Monroe Planning Commission Agenda

Tuesday, April 20, 2021

DATE: April 20, 2021
RE: Information Packet for April 20, 2021 Planning Commission Meeting at 6:00 p.m.

I. Case No. 2021-1-1 (TABLED)—Consideration of a Site Plan for Thornton's

SIDE ELEVATION

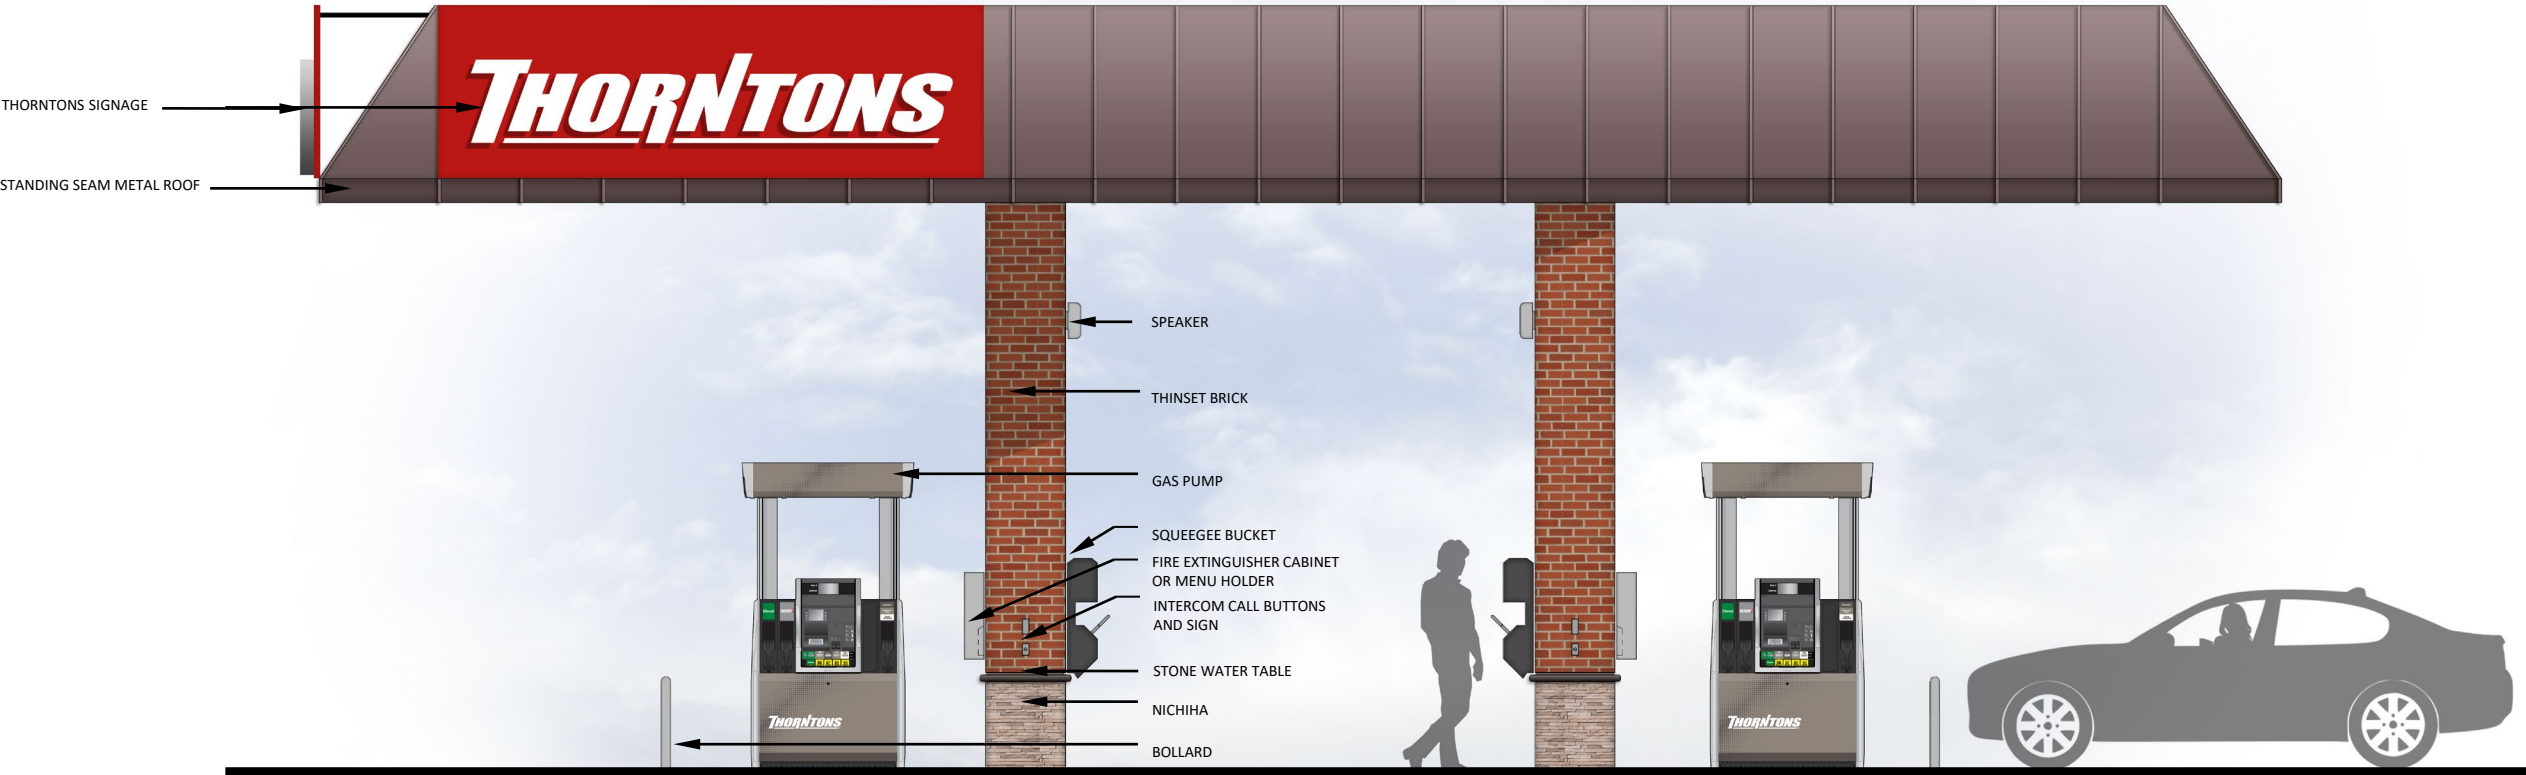
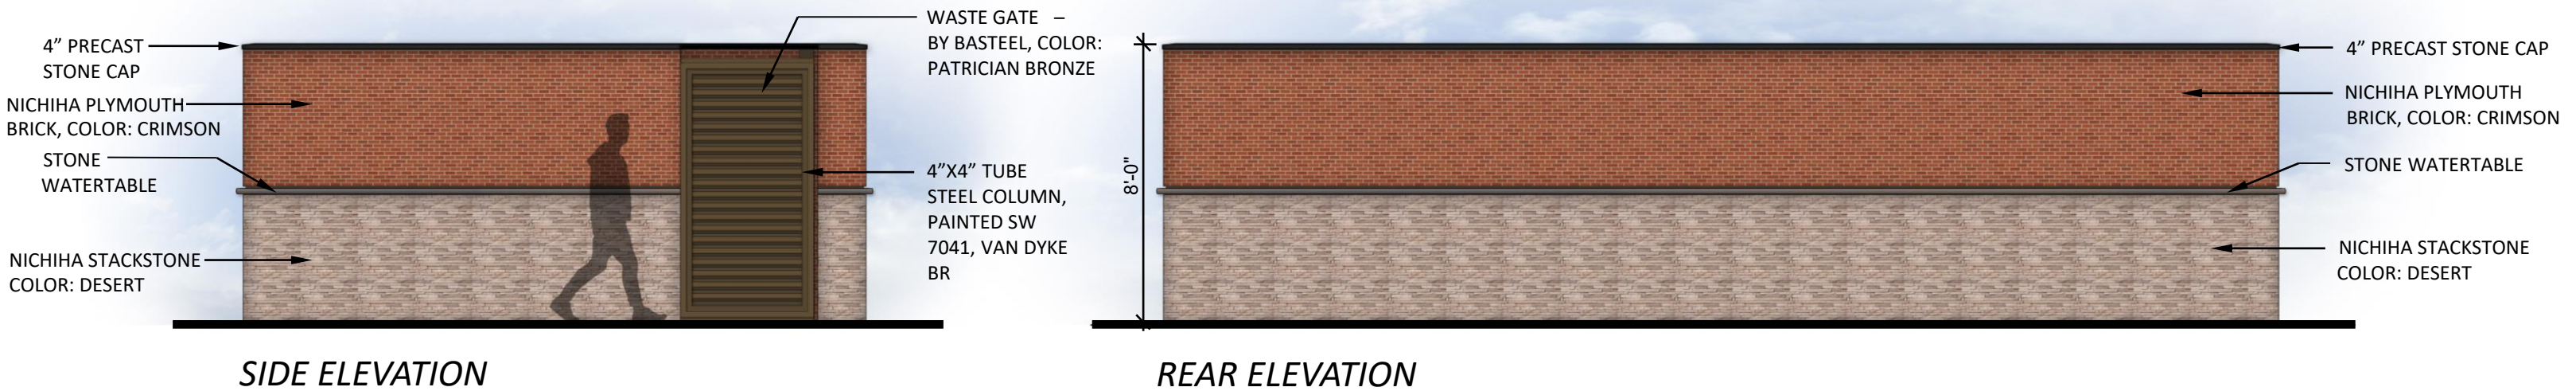
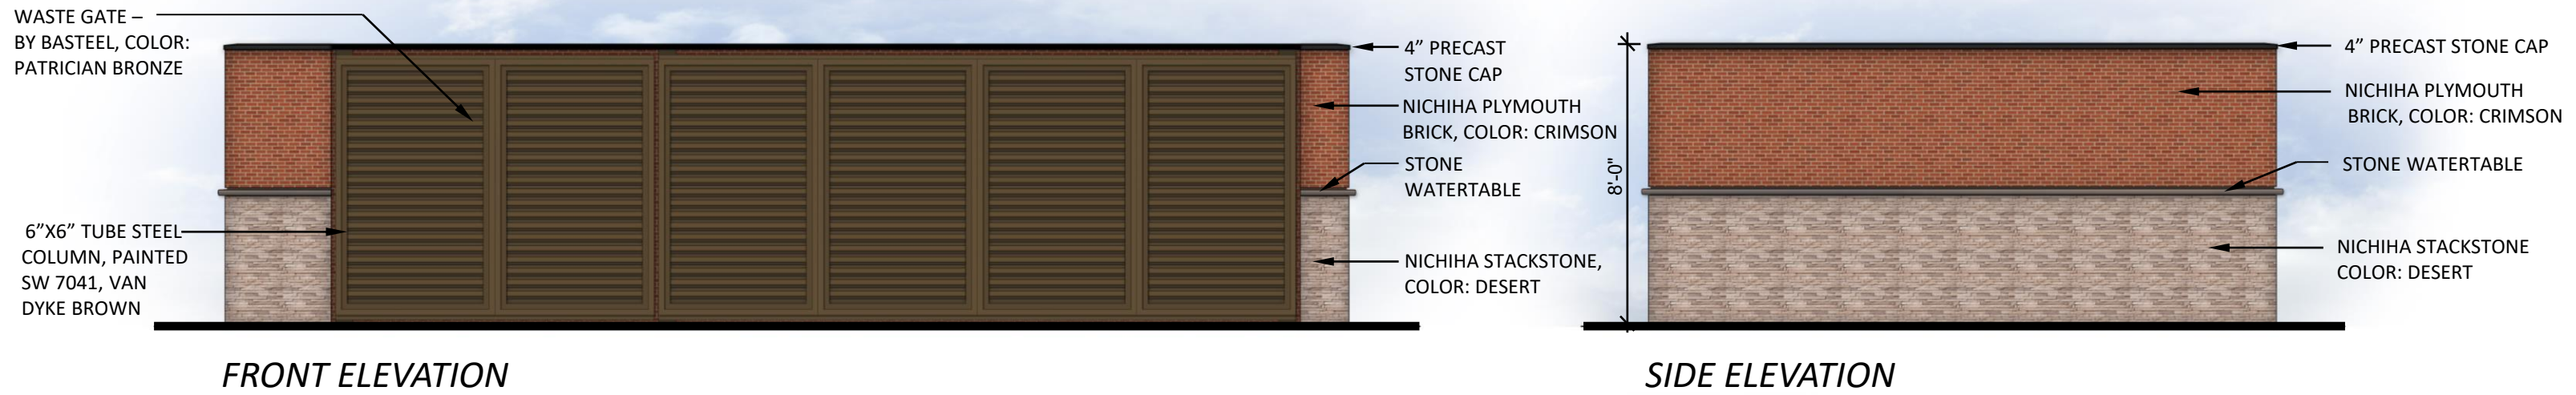
- The auto refuel canopy, proposed at 14'6" clearance height, exceeds the maximum 14-foot clearance height. Please revise **(1204.04(D) (15))**.
- The truck refuel canopy, proposed at 17'6" clearance height, exceeds the maximum 14-foot clearance height. Please revise **(1204.04(D) (15))**.

- Both the auto and truck refuel canopies are flat roof as opposed to gabled as required. Please revise **(1204.04(D) (15) and (1204.04(D) (4))**.
- In order to maintain consistency across plans, Staff requests revision of the elevation drawings on the truck refuel canopy as it shows 5 fuel pump stations where there are only presently 4 proposed.
